FORM APPROVED
OMB NO. 1004-0137
Expires: January 31, 2018**SUNDRY NOTICES AND REPORTS ON WELLS**
Do not use this form for proposals to drill or to re-enter abandoned well. Use form 3160-3 (APD) for such proposals.5. Lease Serial No.
NMNM14157

8. Well Name and No.
TRES-MITCH 30 19. API Well No.
30-025-32688-00-C110. Field and Pool or Exploratory Area
SAND DUNES11. County or Parish, State
LEA COUNTY, NM**SUBMIT IN TRIPLICATE - Other instructions on page 2**

PROPOSED PLUG & ABANDONMENT

Permanent Abandonment of Federal Wells
Conditions of Approval (LPC Habitat)

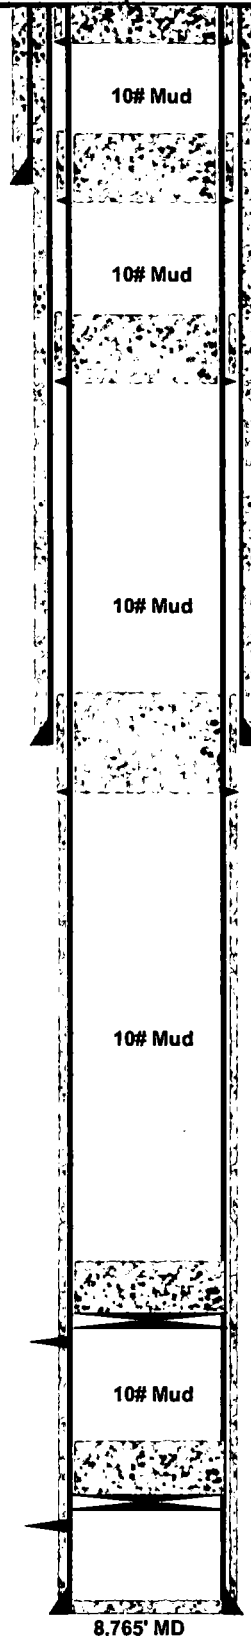
Below ground level dry hole marker required

** BLM REVISED ** BLM REVISED ** BLM REVISED ** BLM REVISED ** BLM REVISED **

Proposed: *Dump Bail 35'*
 2. Spot 25 sx (200') CI H @ 8,570' - 8,370'.
 1. Set CIBP @ 8,570. Tag. Circ 10# salt gel.

In lieu of a cement plug across perforations in a cased hole (not for any other plugs), a bridge plug set within 50 feet to 100 feet above the perforations shall be capped with 25 sacks of cement. If a bailer is used to cap this plug, 35 feet of cement shall be sufficient. Before pumping or bailing cement on top of CIBP, tag will be required to verify depth. Based on depth, a tag of the cement may be deemed necessary.
